## HEALTH OFFICER DECISION

Application Type: Building Site Application -  
Residential

Memo #: 66757  
Tax ID #: 062302-1-002-2007  
RP ACCT ID: 1077536  
Expiration: 10/16/2022

4457 SE SALMONBERRY RD  
Port Orchard WA 98366

SITE PLAN

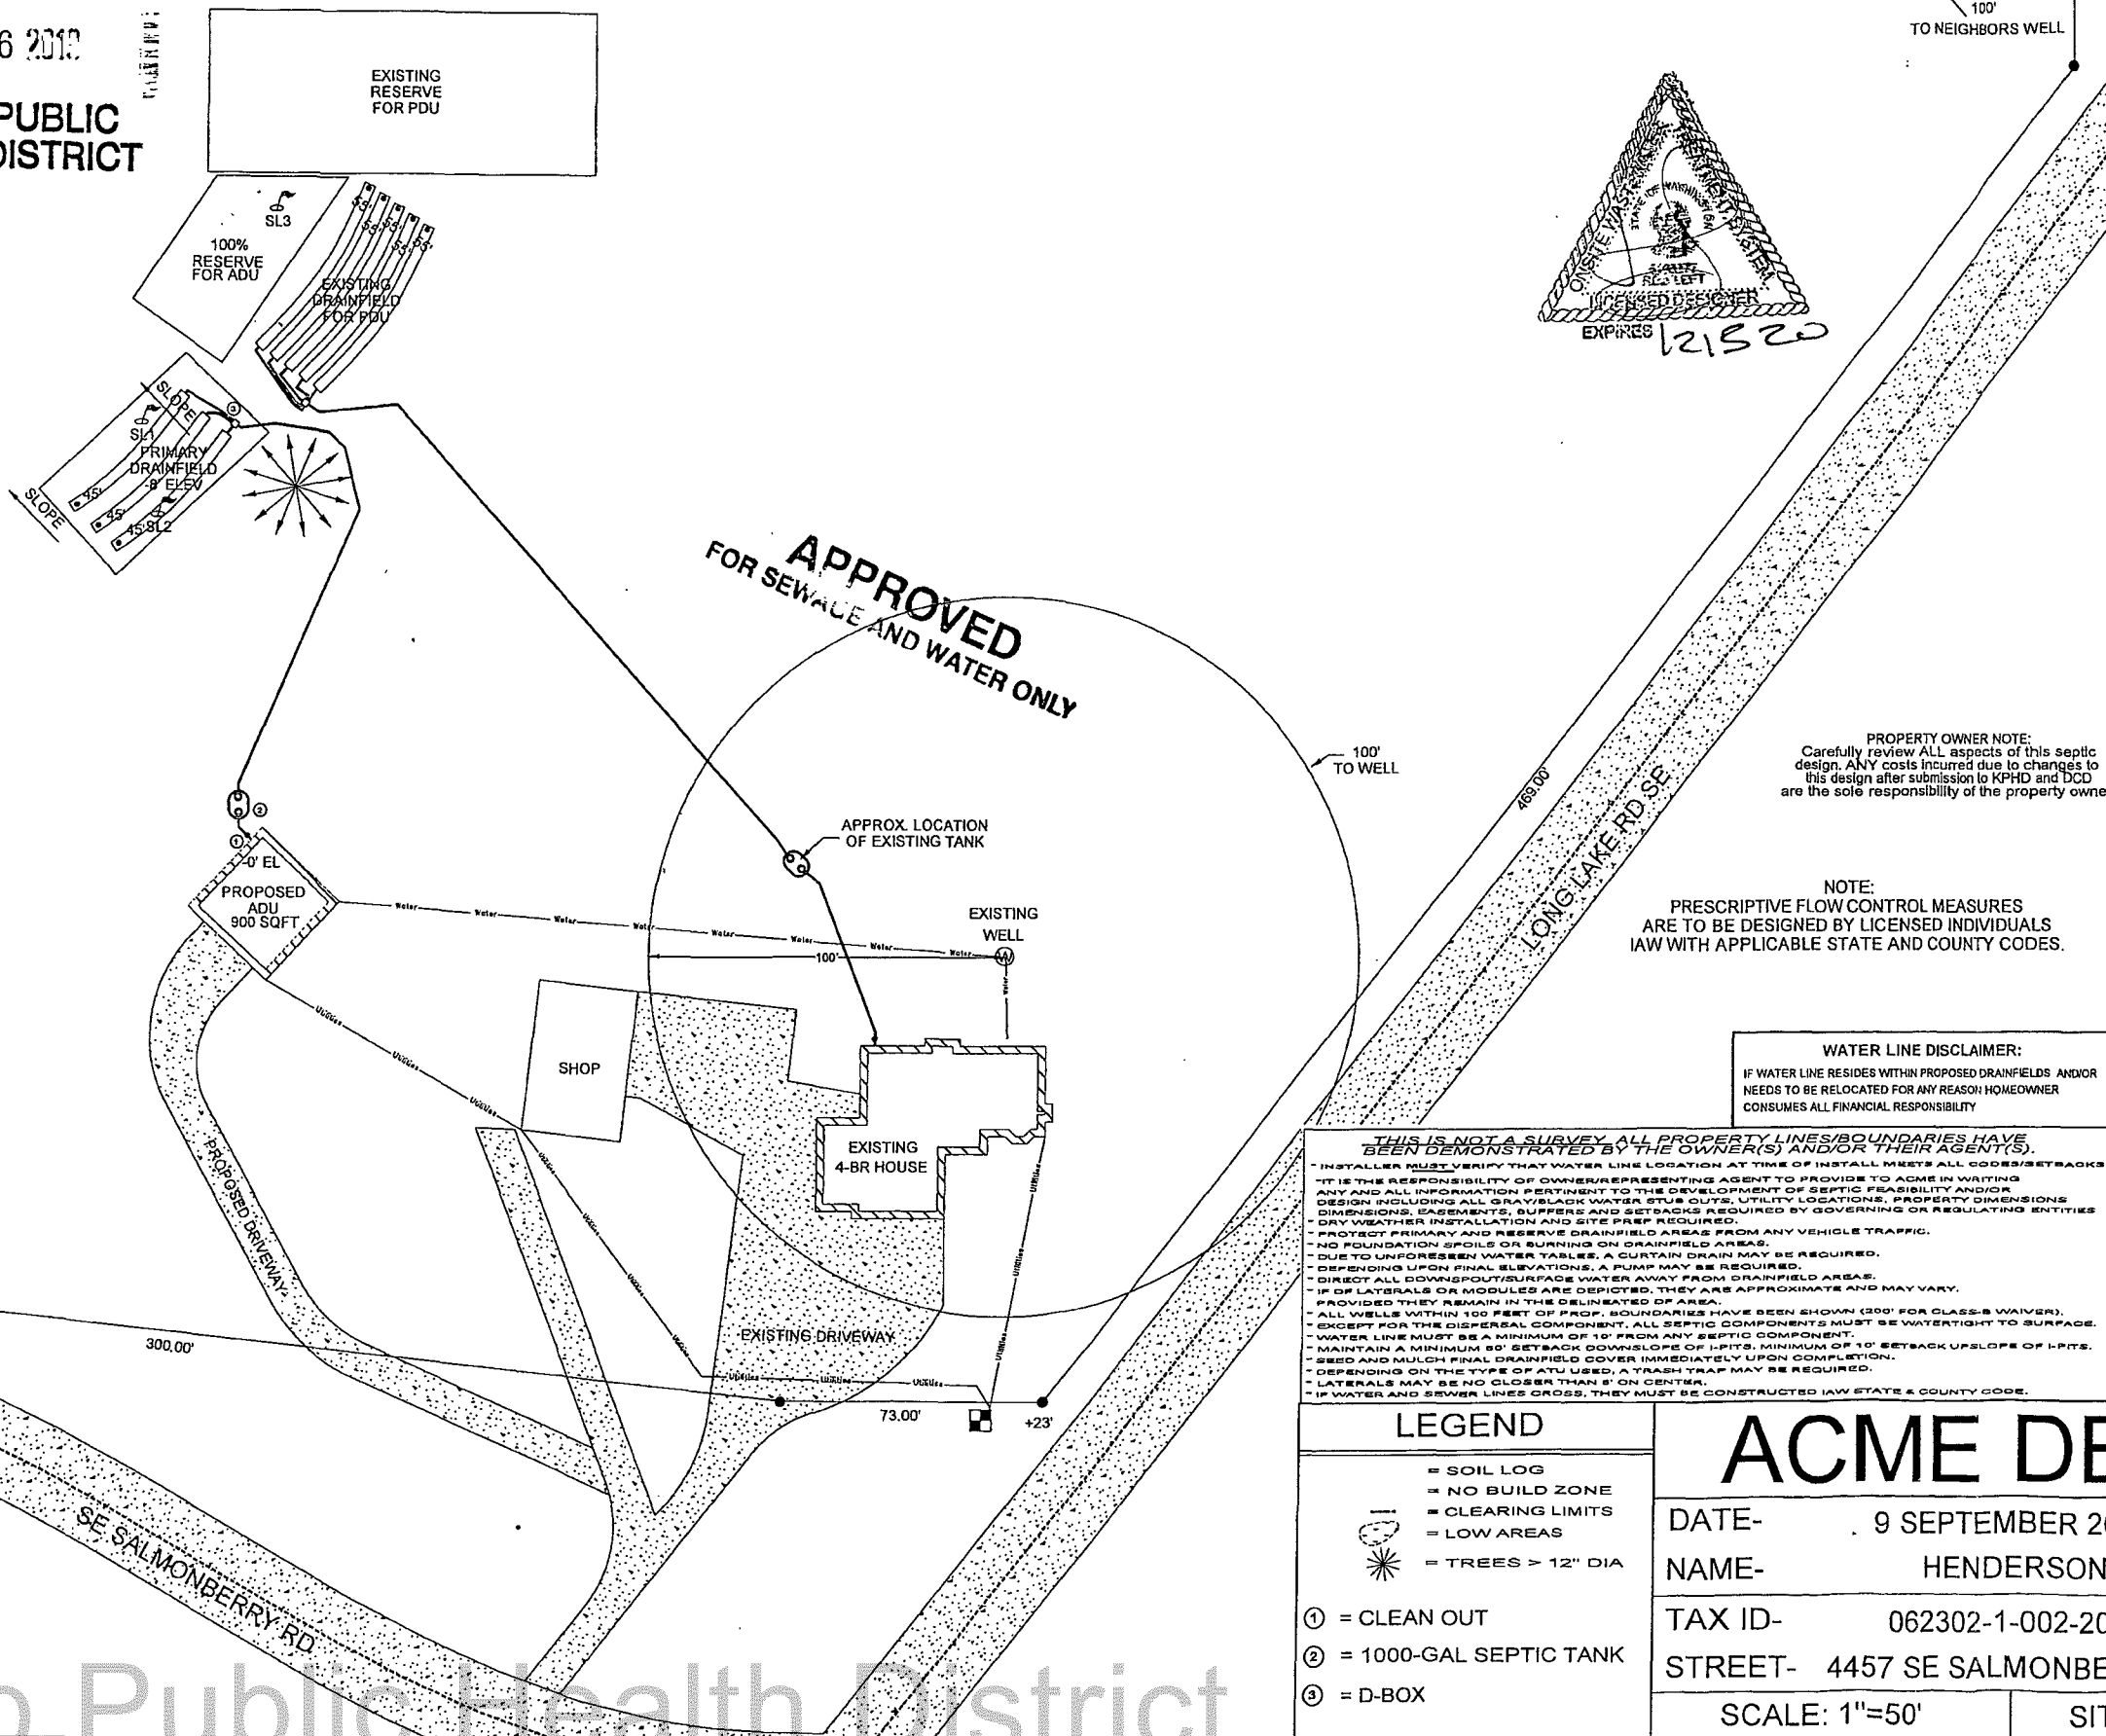
<b>Approved</b> (See Conditions Below)	Name of Inspector: <i>Sam Ader</i>	Date: <i>10/10/2019</i>
The septic/waterline crossing must be sleeved IAW KPHD policy #26
